AGENDA

HISTORIC DISTRICTS
REVIEW BOARD
JANUARY 11, 2022
5:30 PM
Meeting Virtually

1. Stucco Guidelines. Staff is requesting HDRB review of and comment on guidance document for stucco color, texture, materials and where acceptable in the Historic Districts for future adoption. (Carly Piccarello, cpiccarello@santafenm.gov)

2 PROPOSED SITE PLAN SCALE: 1/8" = 1'-0"

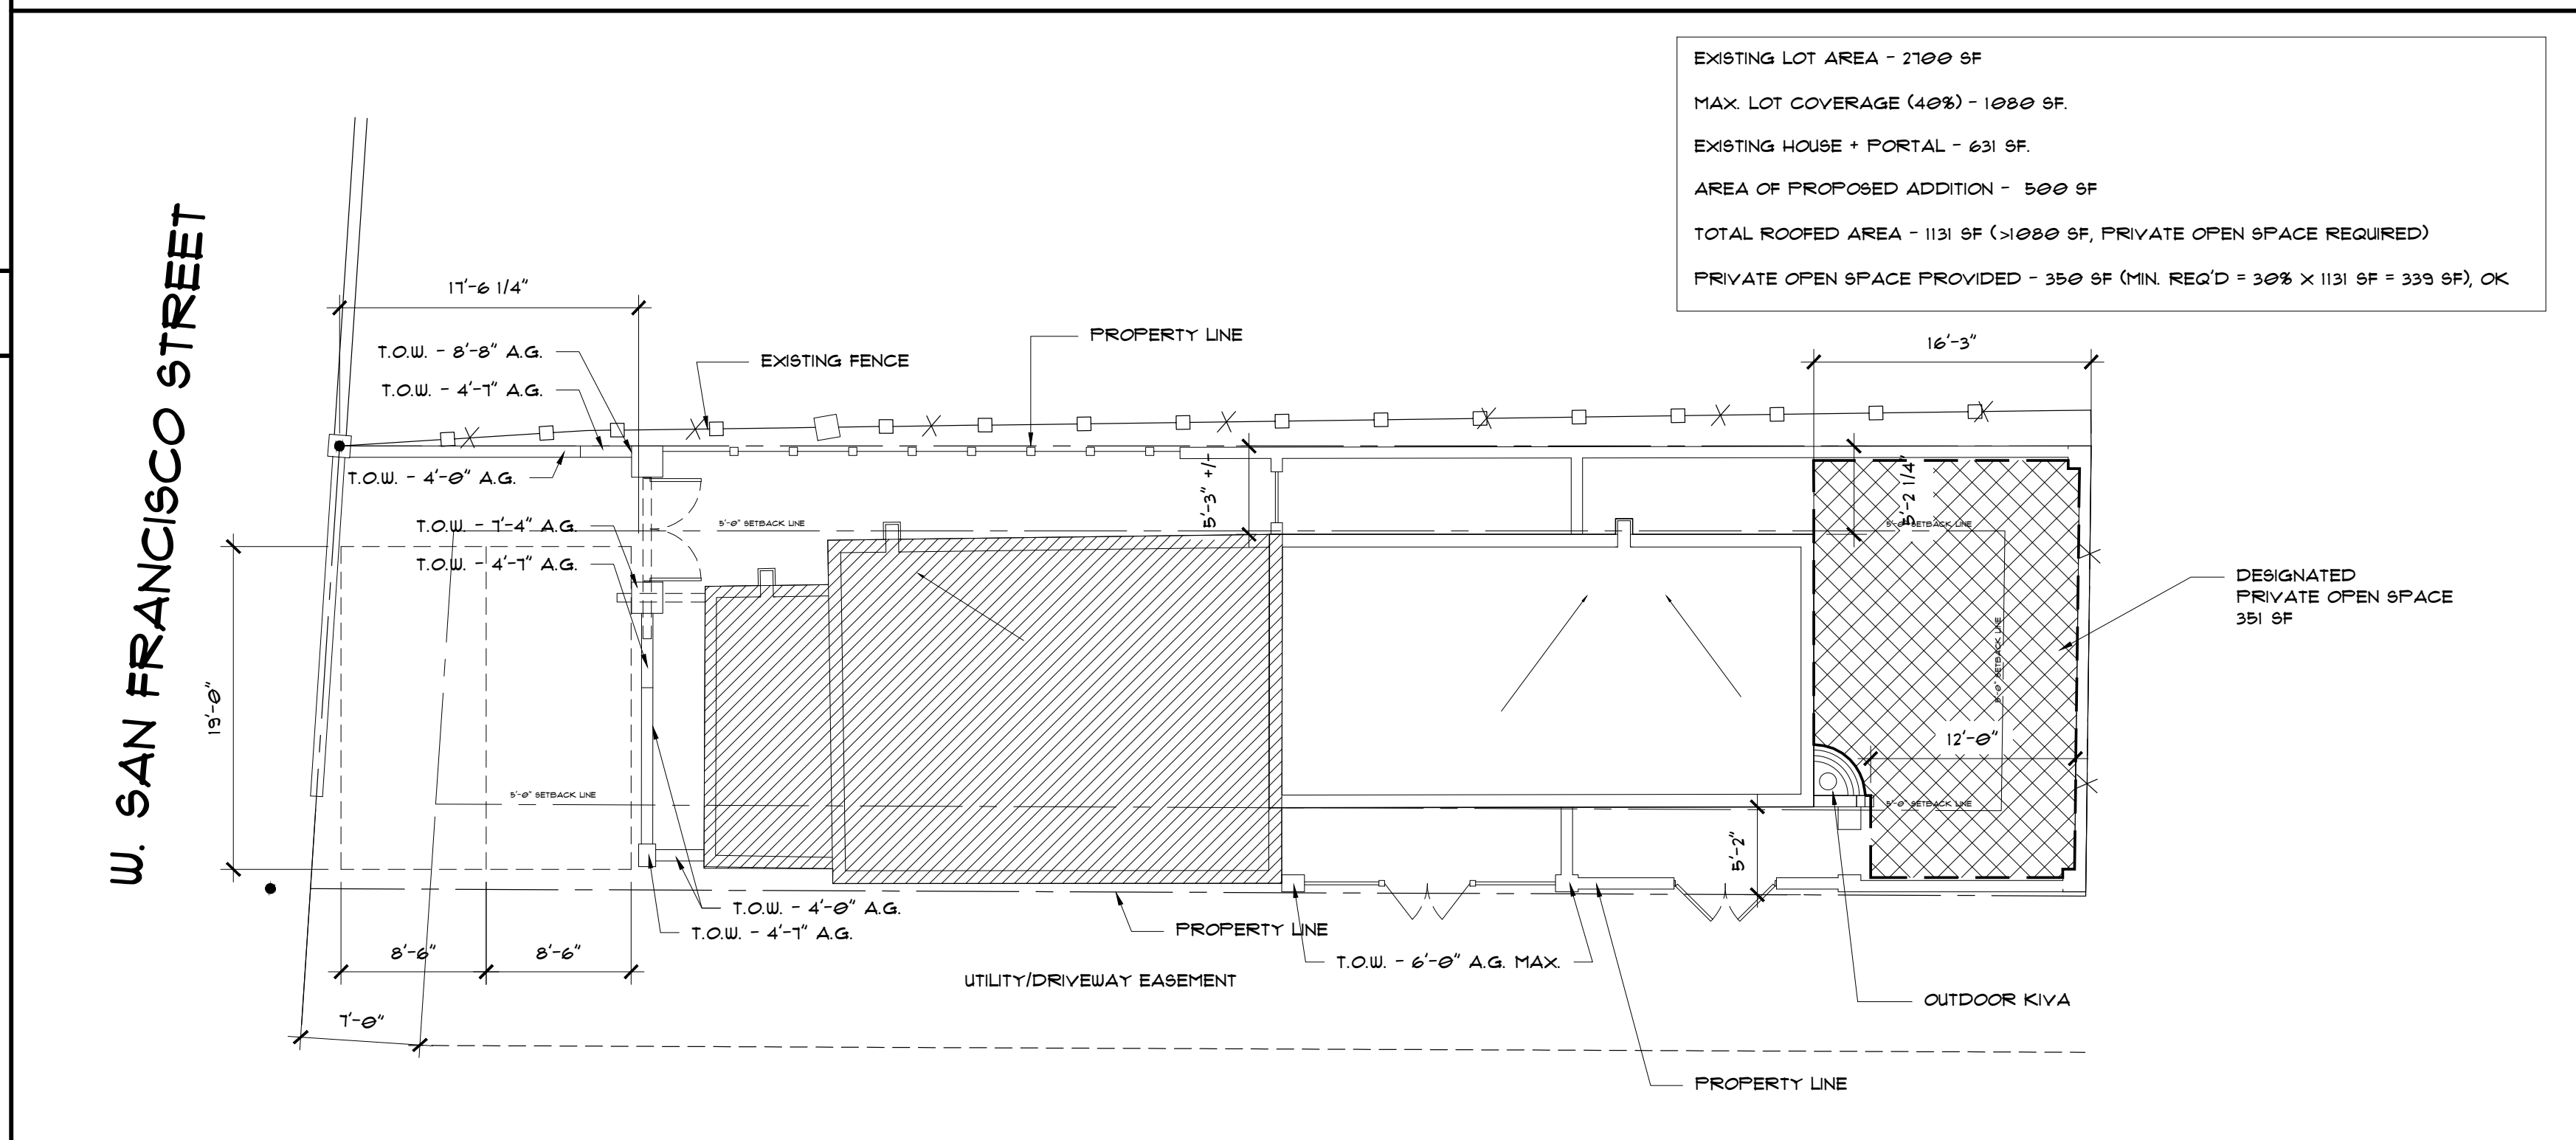
Mr. Beili pulled up the site plan. He said they want the garden to be private and hoped to do a 6-8 foot wall, the same as across the driveway.

Member Bienvenu said he was willing to modify his motion if it is a fact the approval has not exceeded 6 feet. He modified his motion to say six feet on the north and west sides.

Member Biedscheid asked to clarify for the record she does not know if the Board has ever approved 6-8 feet walls; *this* Board has never approved greater than six foot walls. She said it is important for harmony in the neighborhood that this communicates with its neighbors. That is why the Board advocates for slightly lower walls. This is a fair compromise. She appreciated the applicant's willingness to compromise.
